Messing and Inworth Action Group Limited (MIAG)

Messing-cum-Inworth Parish Council (Mcl PC)

Position paper and response to documents received from

National Highways Limited (NH)

4.07 Chainage 880 to Chainage 1000

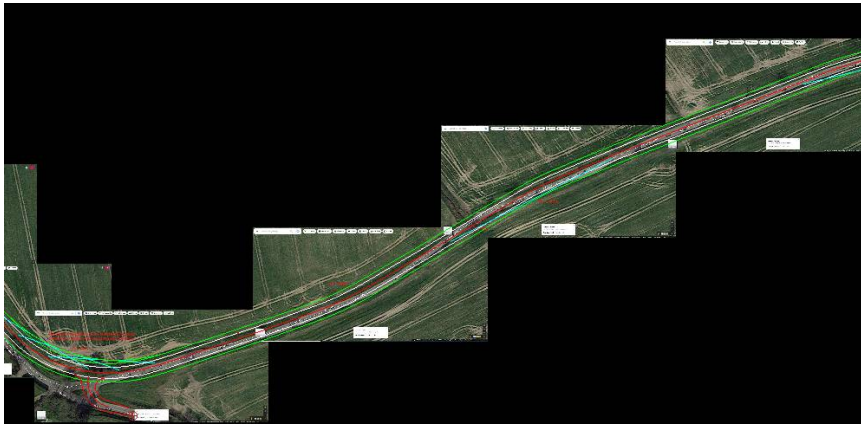
This section of the alignment presents a problem in that the existing radius here is only about 40m. The lowest value for a CD 109 compliant horizontal radius is 90m but as stated previously this radius would require very long transition lengths for a 70kph design speed. The design speed calculated for this road improvement (see Appendix 1) was 70kph, category A. For a category A design, a relaxation in horizontal radius of up to 3 steps is permitted. A 90m radius is a 4-step relaxation and is therefore a departure from standards. It would also require a considerable amount of verge widening to accommodate a stopping sight distance of 120m appropriate for a 70kph design speed. This would push the back of verge on the inside of the curve approximately 25m into the property on the south side, measured from the existing road edge. A reduction in stopping sight distance would also be a departure since there are accesses in this area.

A compromise in the design standards would therefore be necessary to provide a solution that would reduce the impact on properties but still provide a reasonable standard of design. Departures from standards would need to be applied for and could be mitigated by applying a lower speed limit over the length of alignment where the departures occur.

One possible solution would be to provide a 90m horizontal radius curve with transition curves of 49.6m length (ie. half-length) and a stopping sight distance of 70m. This would comply with a design speed of 50kph and with an advisory speed limit of 20mph applied would be a reasonable compromise. However, it would still encroach into the property on the south side by up to 14.5m from the existing road edge. There would still be a considerable impact on mature trees and hedgerows. Overhead cables and poles would also need to be moved.

1.0 From Kelvedon Road into Harborough Hall Road assuming no vehicles parked.

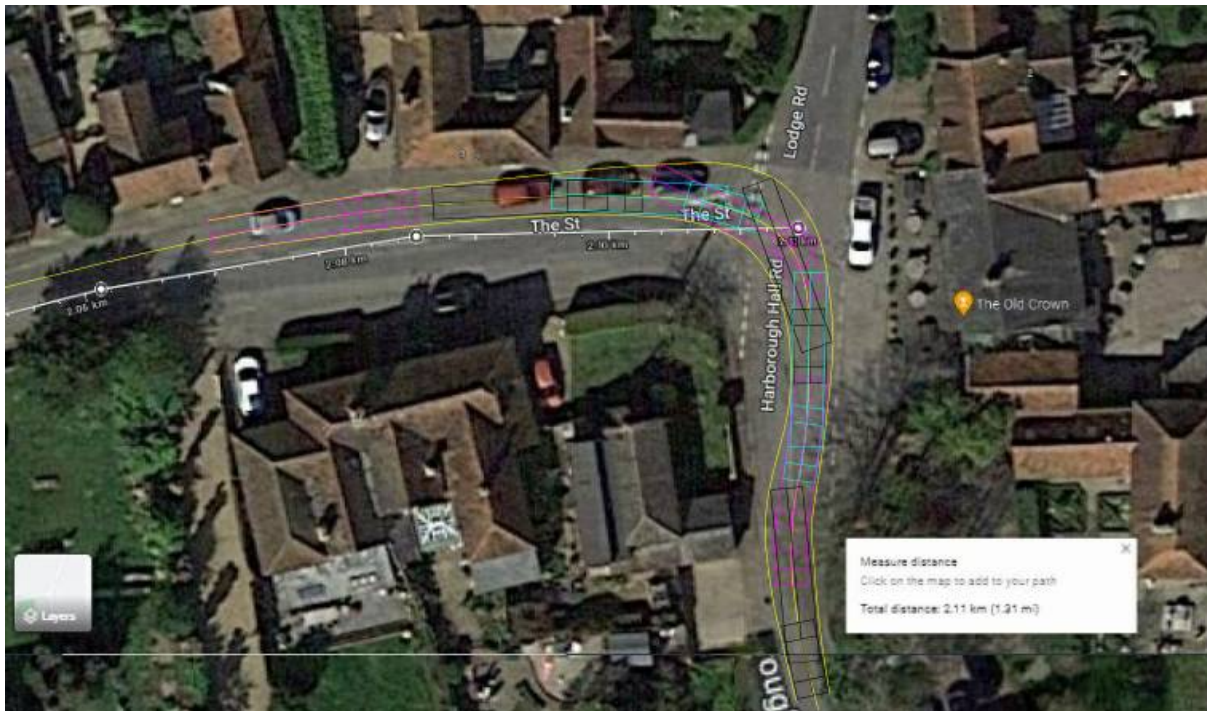
The design vehicle would be able to approach the T junction without impeding vehicles travelling in the opposite direction, on Kelvedon Road. After turning right into Harborough Hall Road, the design vehicle would occupy nearly the full width of the road and therefore require vehicles travelling in the opposite direction to give way. Harborough Hall Road is quite narrow making it difficult for vehicles travelling in the opposite direction to find somewhere to give way.

3.0 Harbrough Hall Road to Kelvedon Road assuming no vehicles parked.

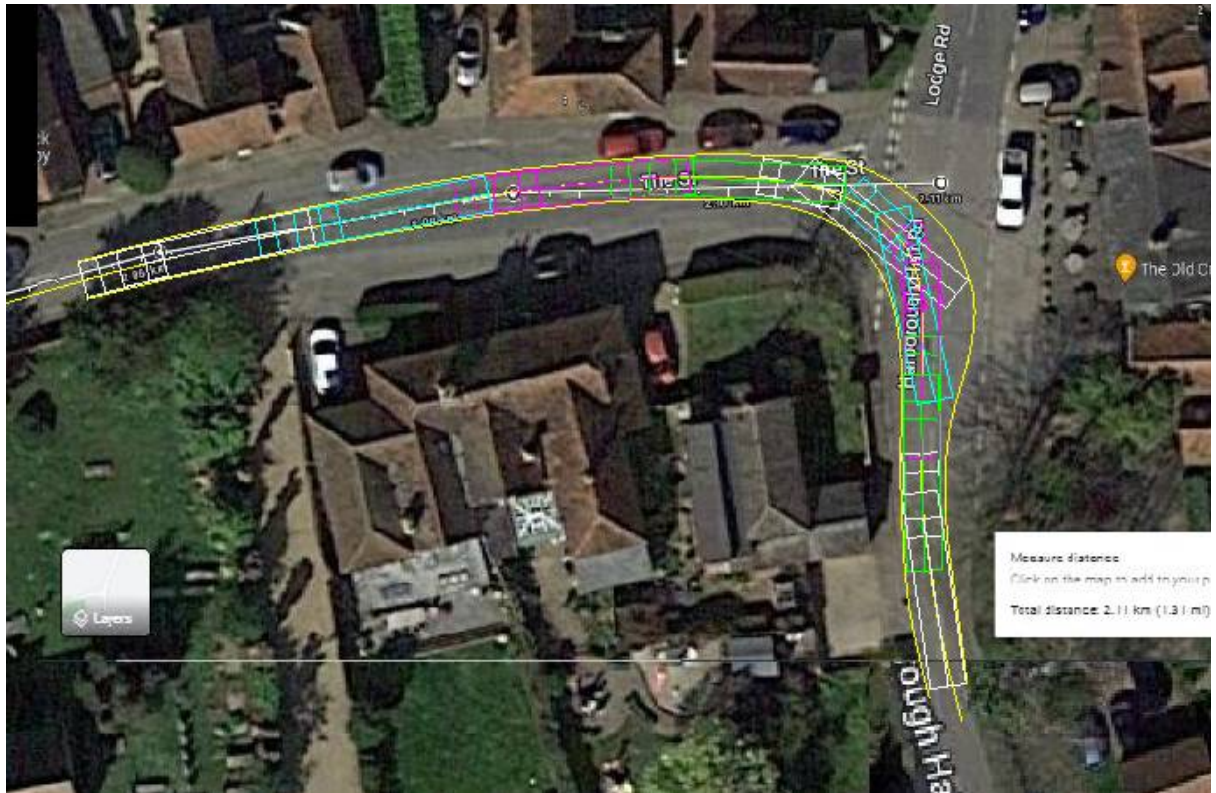
On approach to the T junction along Harbrough Hall Road the design vehicle would occupy nearly the full width of that road. Where the road widens at the junction the design vehicle would need to occupy most of the opposing carriageway before turning left into Kelvedon Road, to allow for the swept path of the trailer. Vehicles travelling in the opposite direction would need to give way but with no parked vehicles there would be space to do this. On entering Kelvedon Road the design vehicle might need to cross into the opposite carriageway slightly. This would not leave much width for vehicles travelling in the opposite direction and most likely they would need to give way to the design vehicle.

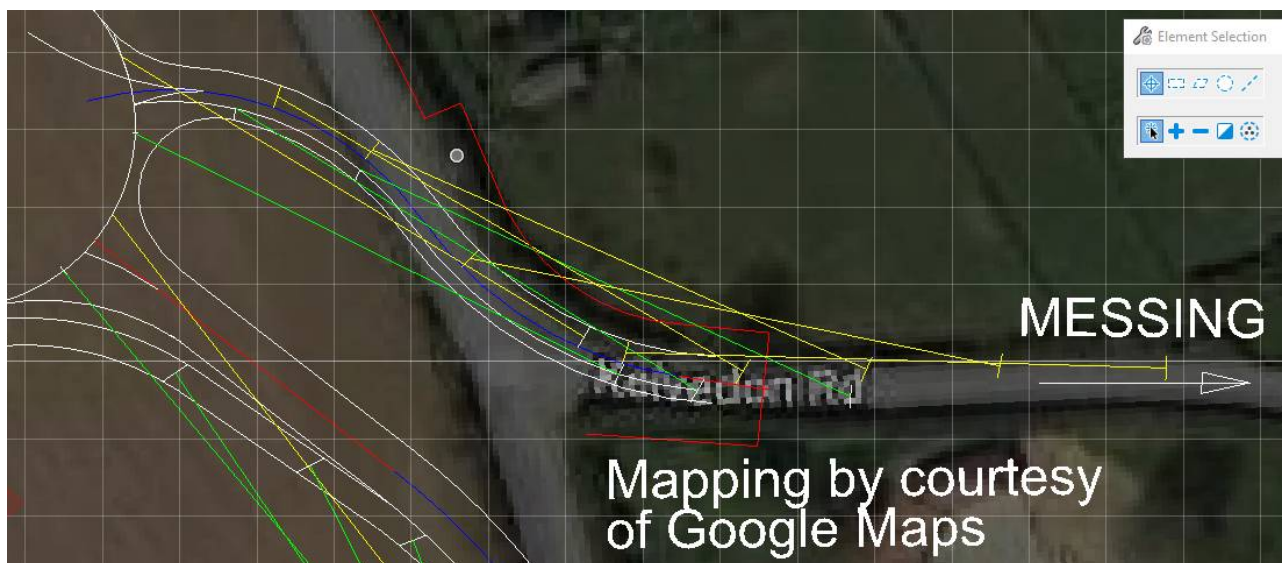
- Forward visibility on approach to the roundabout will not comply with CD 109 unless the sight line passes outside the Red Line boundary into the property “Park Farm” (or “Stonefield Farm”?). Visibility would be further impeded by proposed tree planting.

The alignment is not long enough to make a judgement about visibility in the vertical plane. It would need to be extended further along the B1023 in order to see what the existing carriageway geometry is. The use of a vertical crest curve with $K = 30$ would indicate a 70 kph design speed since no relaxations are permitted on the immediate approach to a junction (CD 109 table 2.10, CD 109, para. 2.11). The sight line would most likely be impeded by property boundaries where it passes outside the Red Line boundary.

2. Inworth Road Roundabout arm to Kelvedon Rd. in the direction of Messing

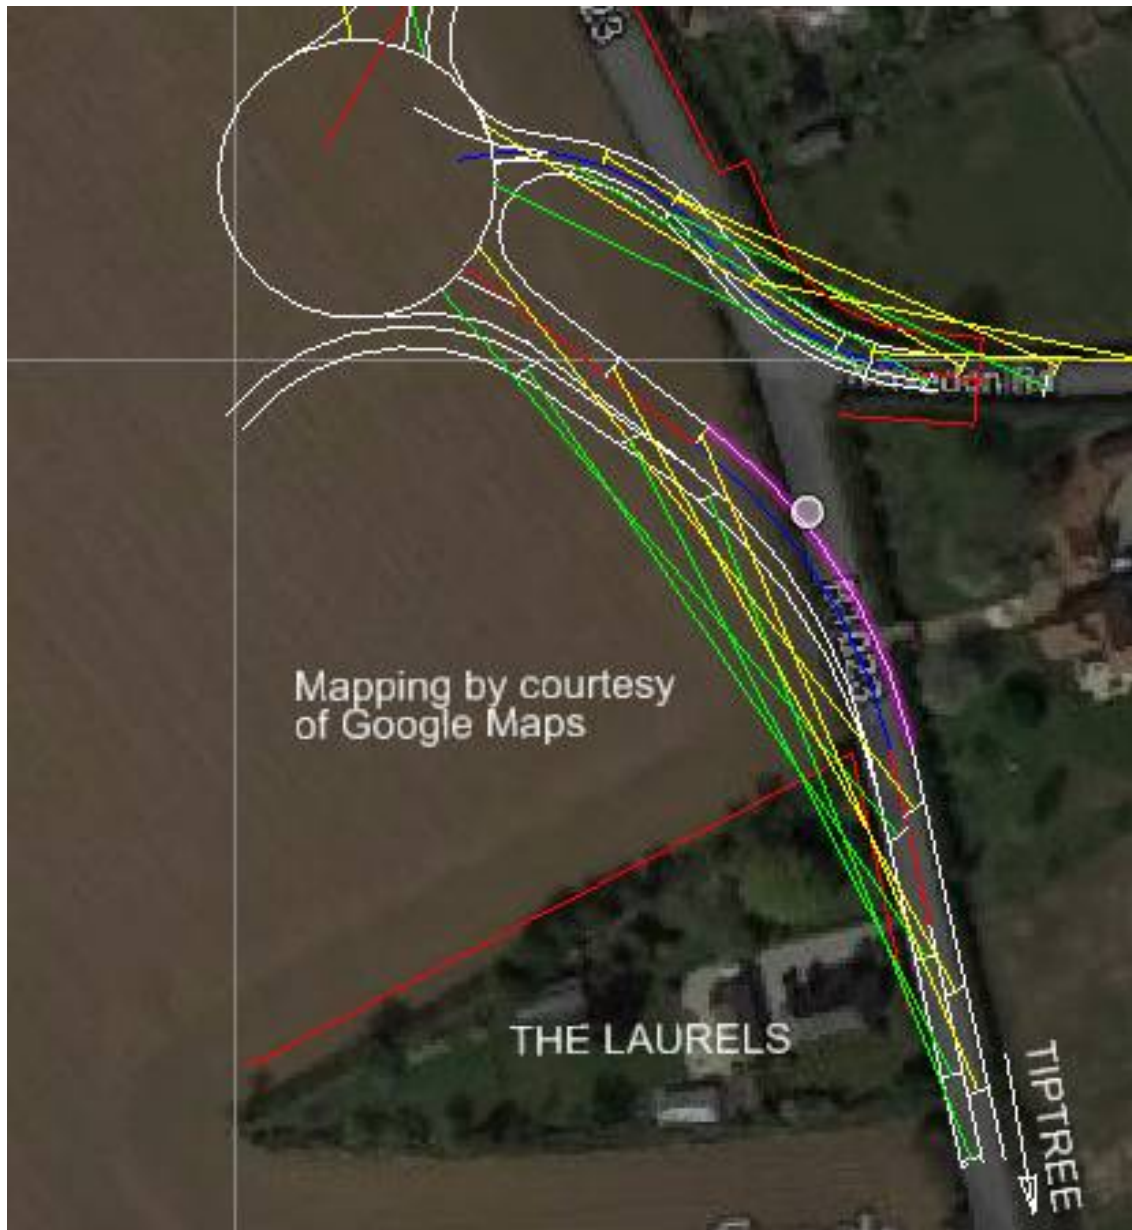
- Forward visibility on approach to the roundabout will not comply with CD 109 unless the sight line passes outside the Red Line boundary on the north side of Kelvedon Road. Visibility may be further impeded by proposed tree planting.

The alignment is not long enough to make a judgement about visibility in the vertical plane. It would need to be extended further along Kelvedon Road in order to see what the existing carriageway geometry is. The use of a vertical crest curve with $K = 10$ would indicate a 50 kph design speed. Since no relaxations in vertical curvature are permitted on the immediate approach to a junction 50kph would be the highest value of design speed for a crest K value of 10 (CD 109 table 2.10, CD 109, para. 2.11). The sight line would most likely be impeded by property boundaries where it passes outside the Red Line boundary.

Type B Link Road

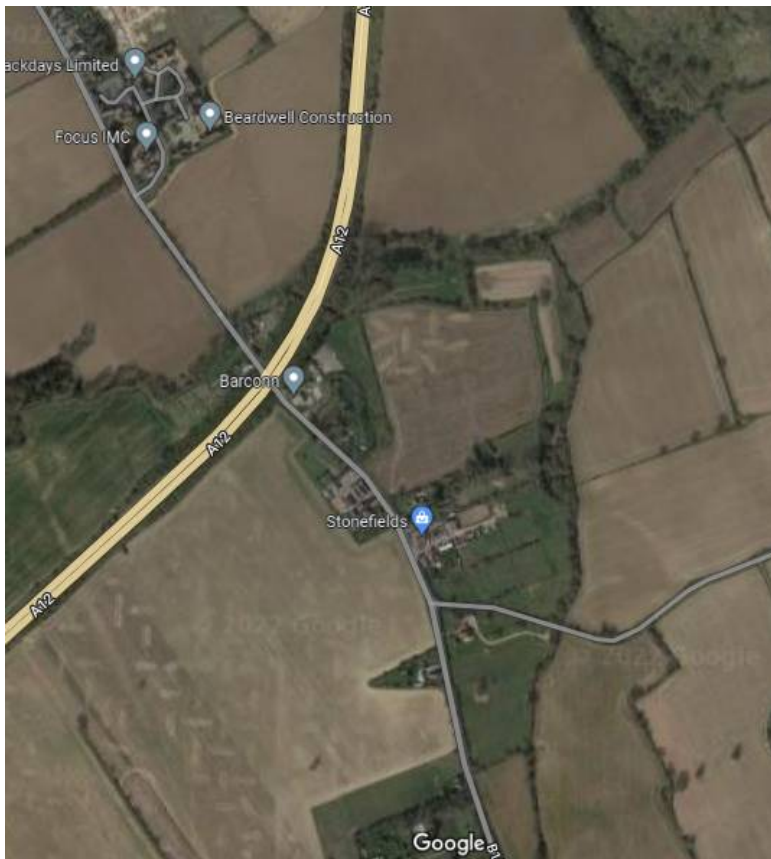
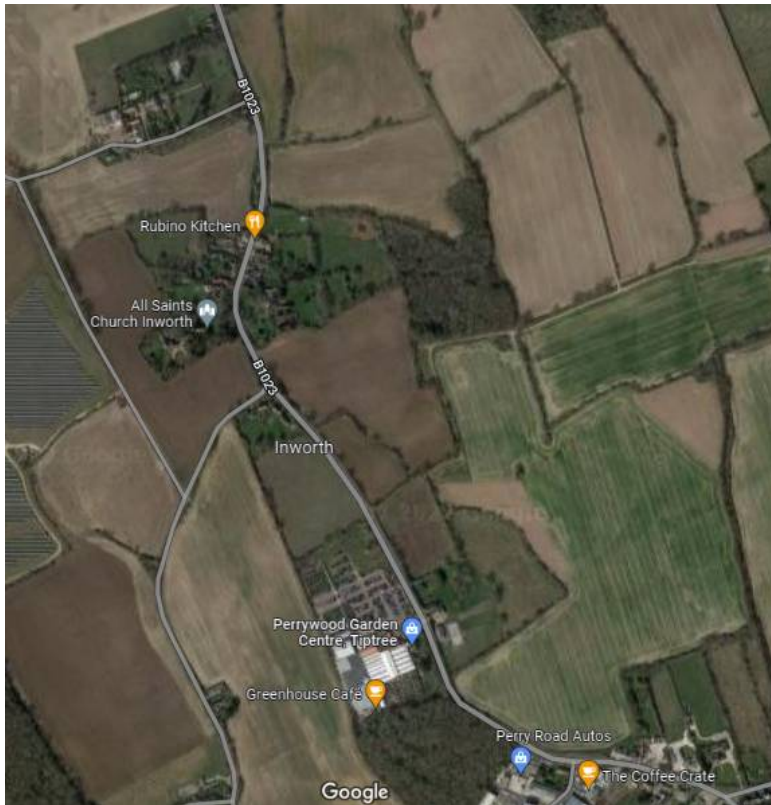
The statement by NH above is not correct as the extracts (copied below) from Essex Highways Technical Manual in relation to a Type B Link Road demonstrate.

In summary, the features that describe Inworth Road, in NH words, as “most accurately” a Type B Link Road are not currently present and are not planned to be provided under the NH scheme proposals.
